**ADDENDUM NUMBER: 01**

**Randolph County Courthouse**  
Clerk of Court Office Renovation  
Asheboro, NC

**PROJECT NUMBER 15210.00**

**January 14, 2021**

# CLARIFICATION NO.001 OVERALL HIGH DENSITY FILING OVERLAY WITH COURTROOMS

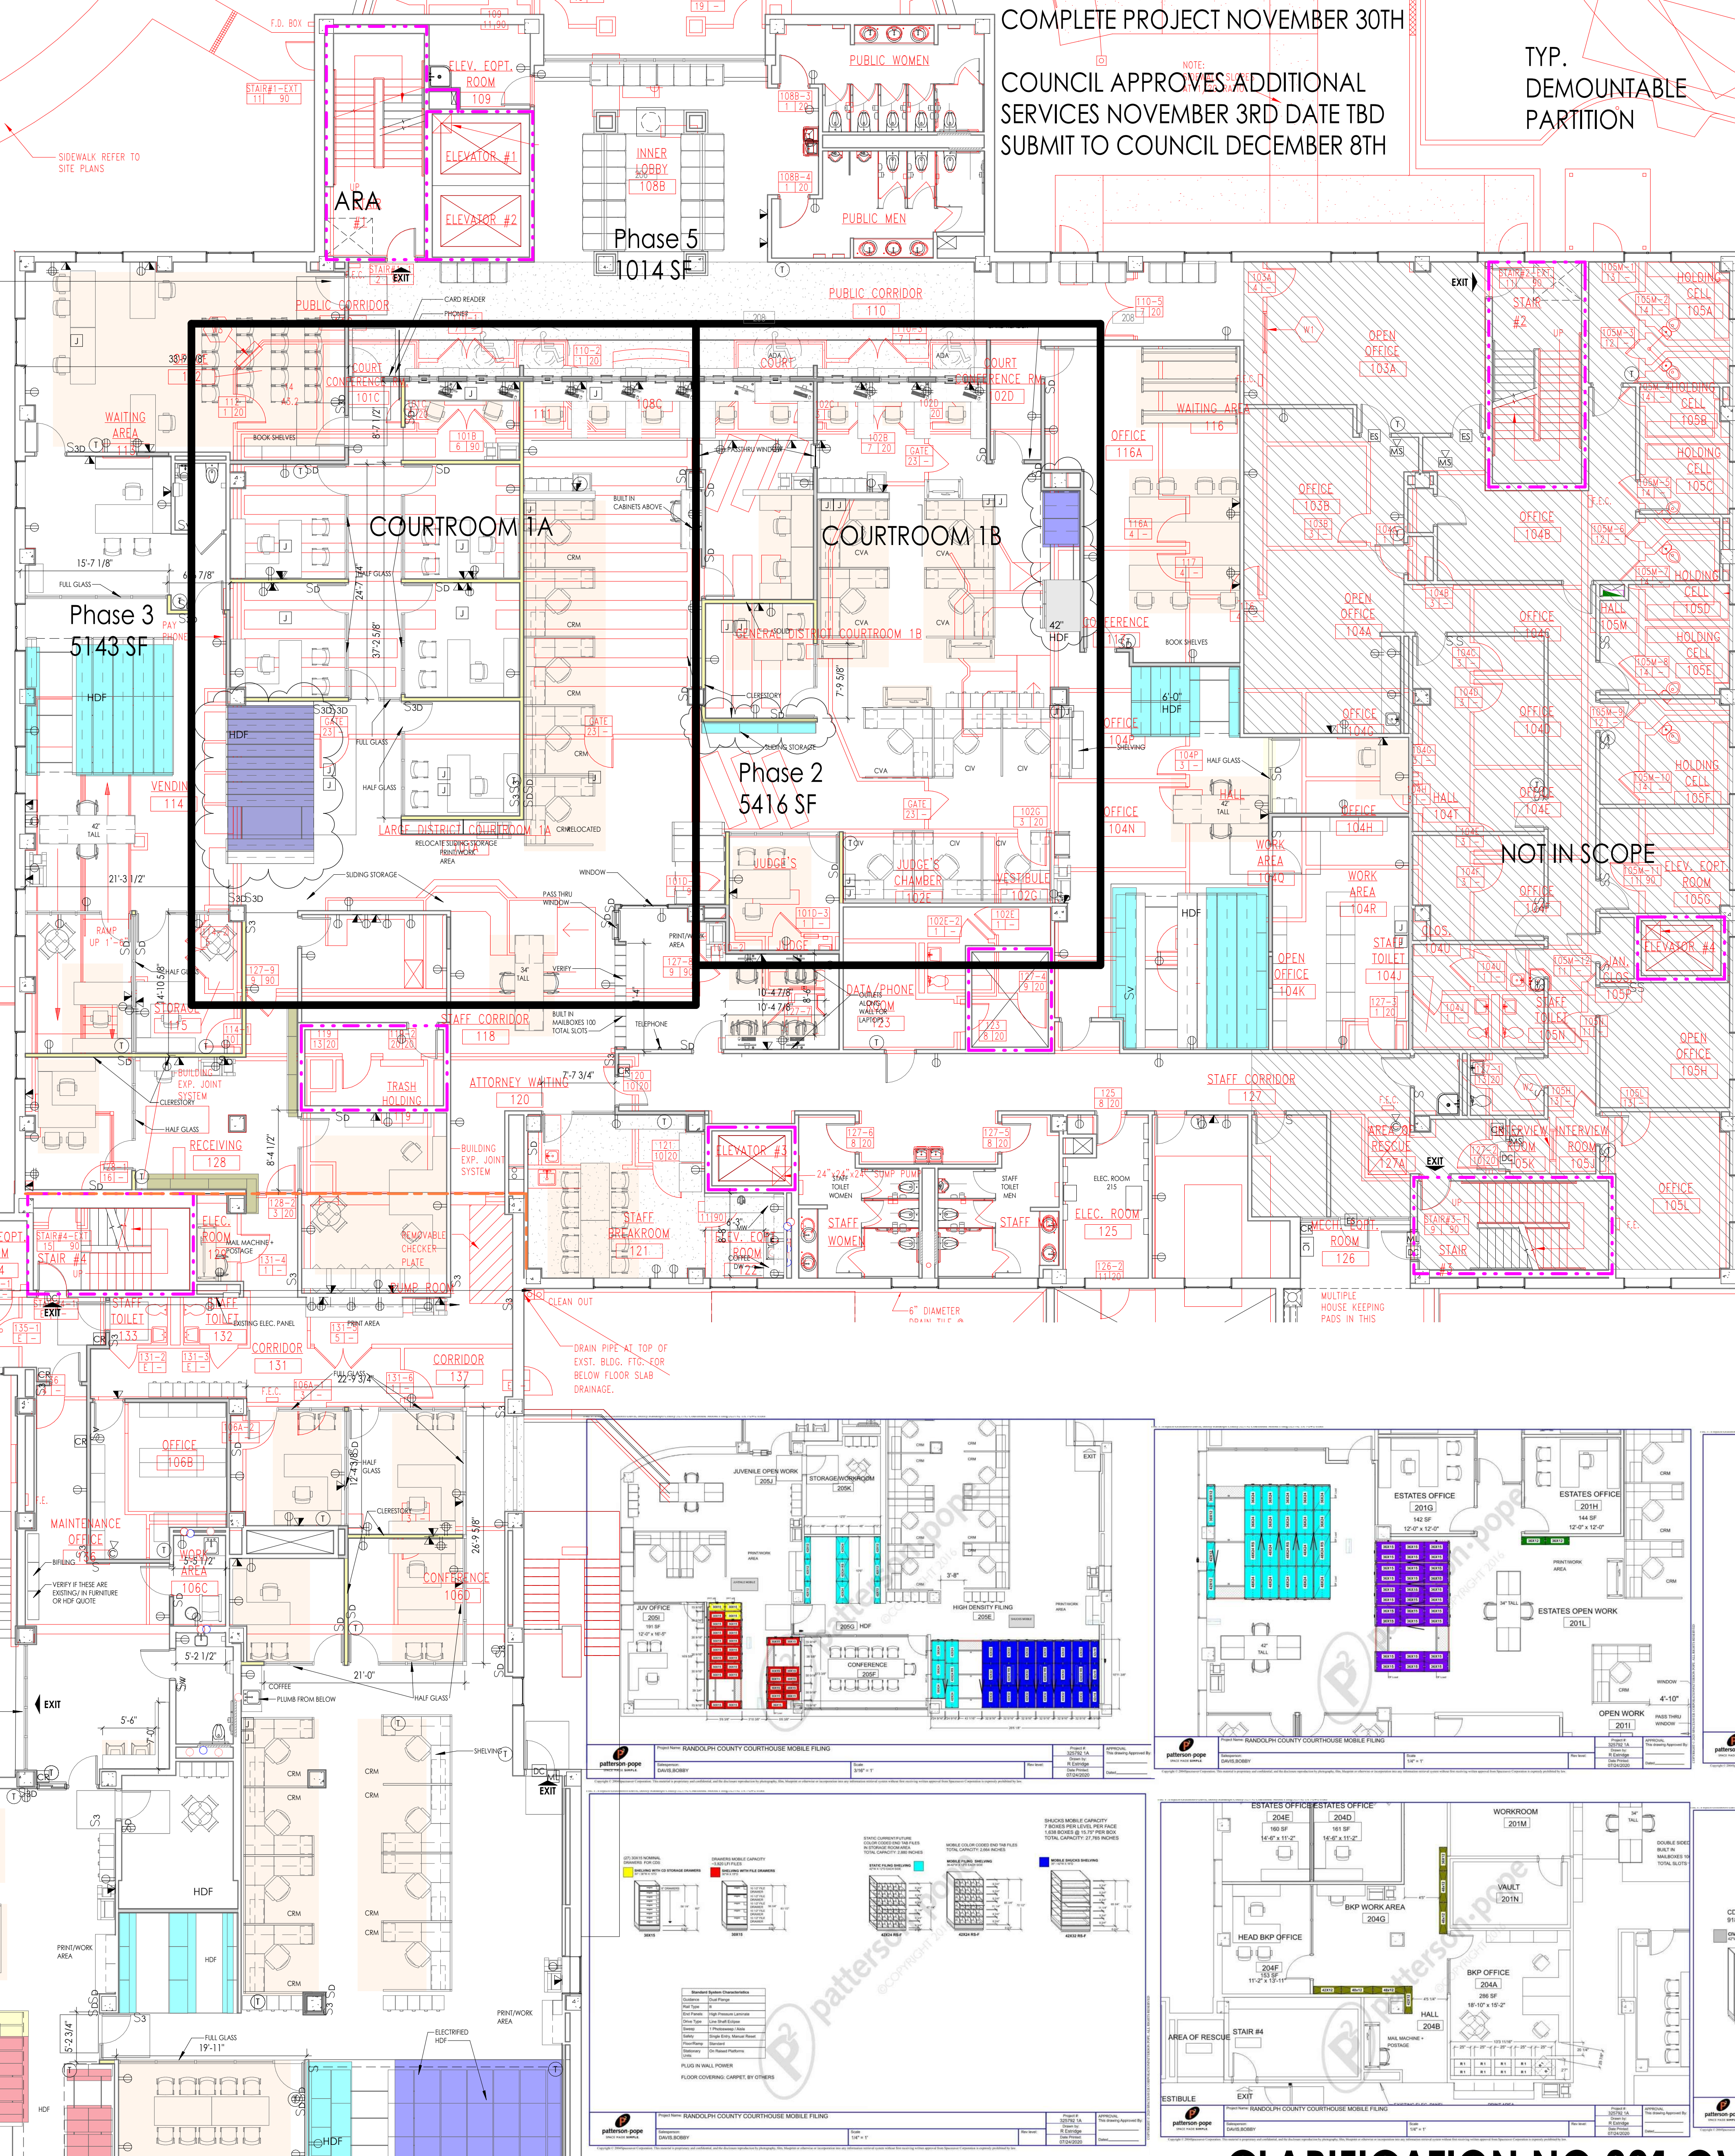
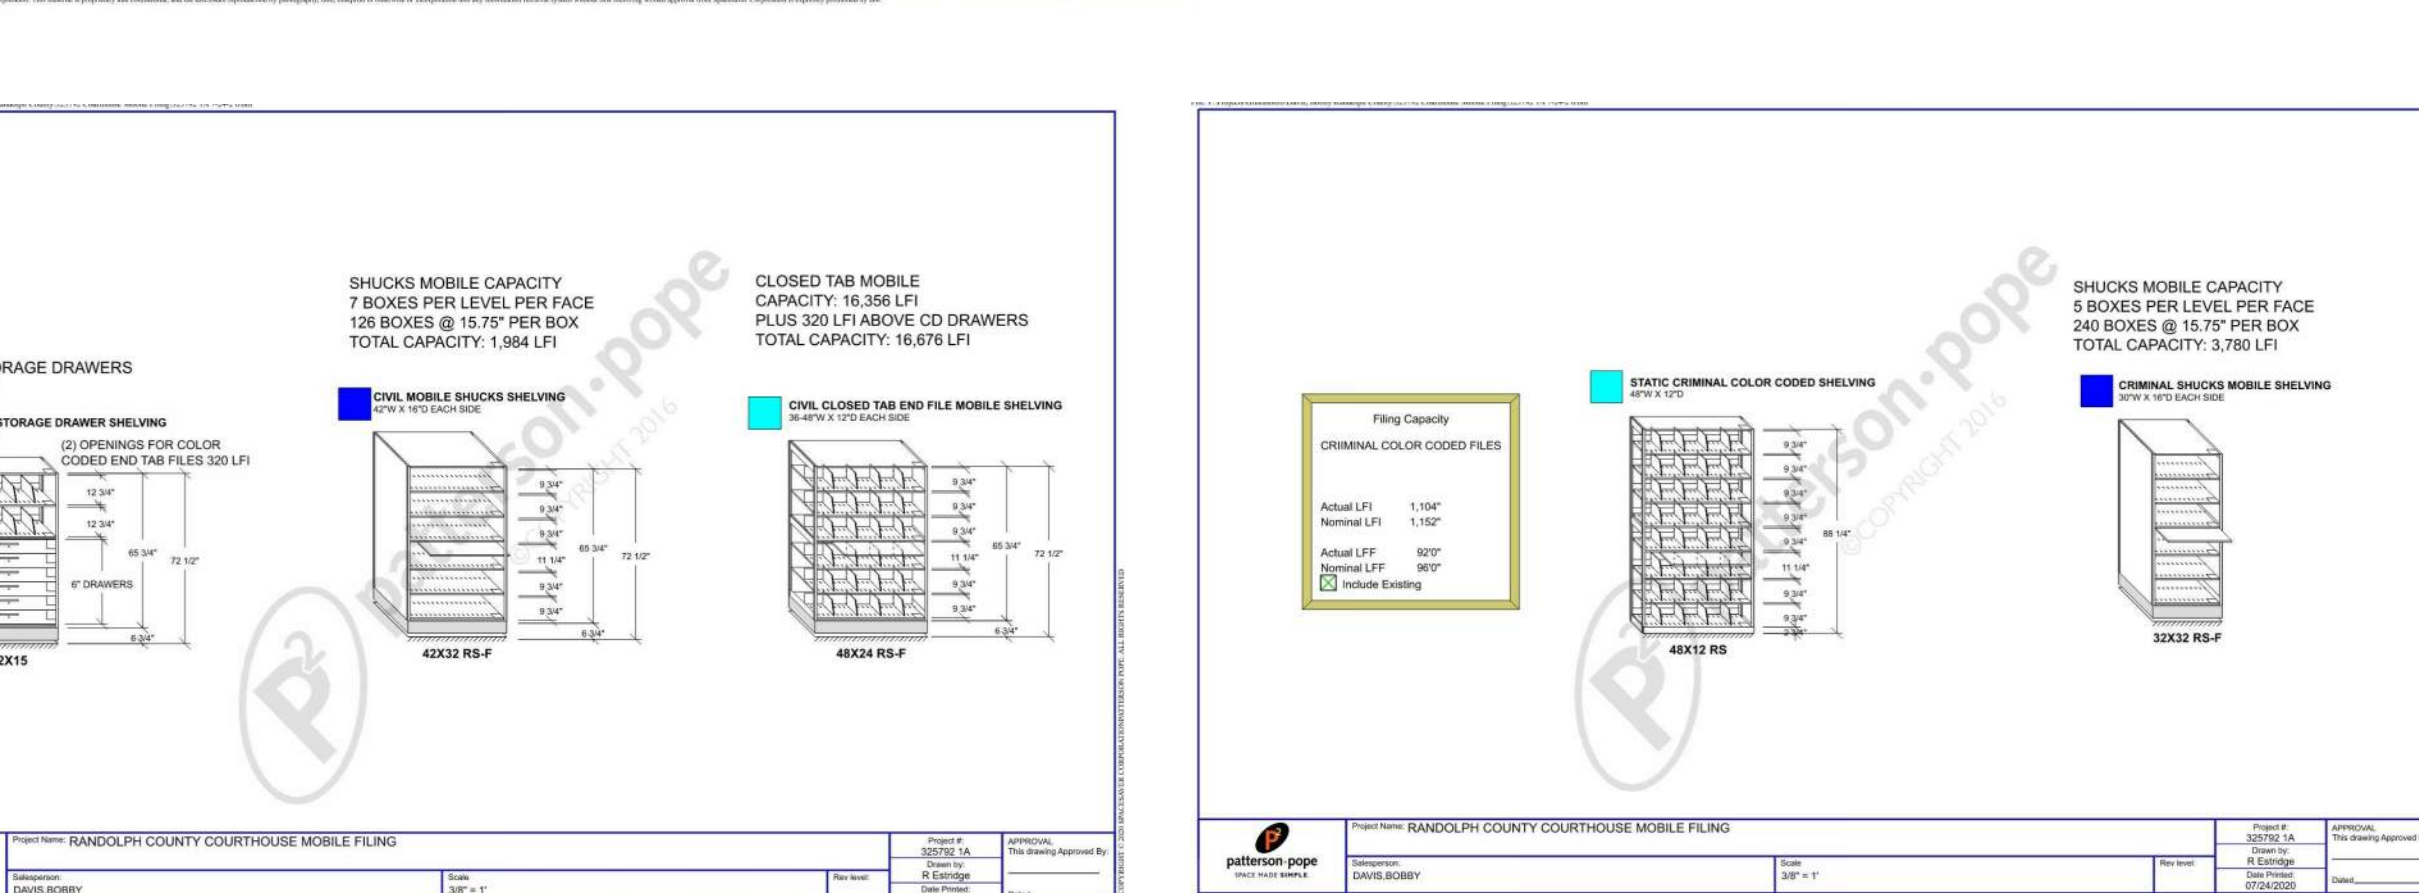
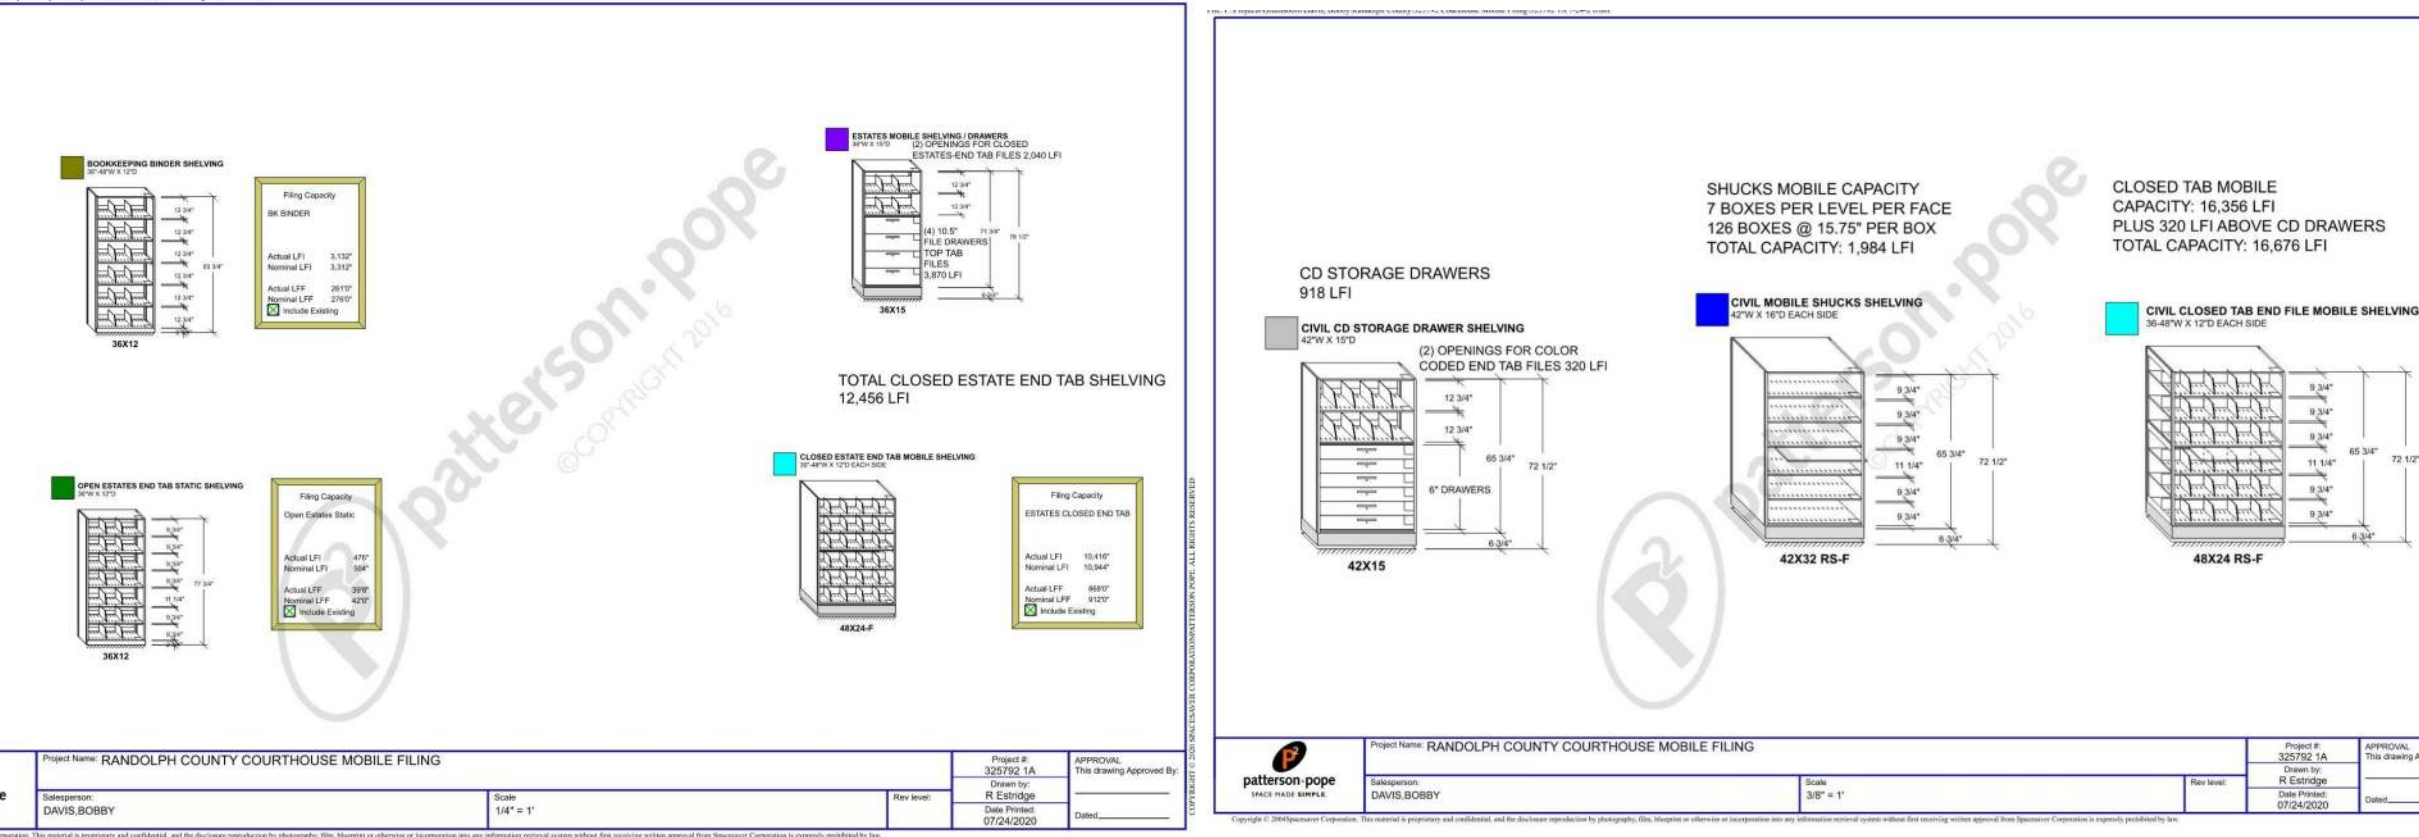
- k. Contractor to remove existing way-finding signage in phase 5 and save for relocation.
- l. Save and relocate existing internal Knox box.
- m. High density filing systems to be manual operation and will not require electrical connections.
- n. All fire extinguishers to be salvaged and removed in the project area and saved for relocation at the correct height.
- o. Tile flooring in existing restrooms in the project area will be removed. Verify if existing slab is depressed and plan to level to receive new vinyl tile flooring.
- p. High density filing will require structural reinforcement, refer to clarification no. 001 regarding

courtroom locations and sensitive locations. Additional coordination will need to take place during this phase of work.

1. Regarding the installation of the Carbon Fiber Reinforcement of Concrete Ribs/Joists, are there any access restrictions on Level 1 that must be observed when performing the work?

- a. Response – Refer to Clarification No.001, some locations are directly above the courtroom and will require additional coordination.
2. The Pro-Forma Construction Contract has a discrepancy regarding Liquidated Damages. The written amount is four hundred dollars, but the numerical amount is \$250. Which is correct?
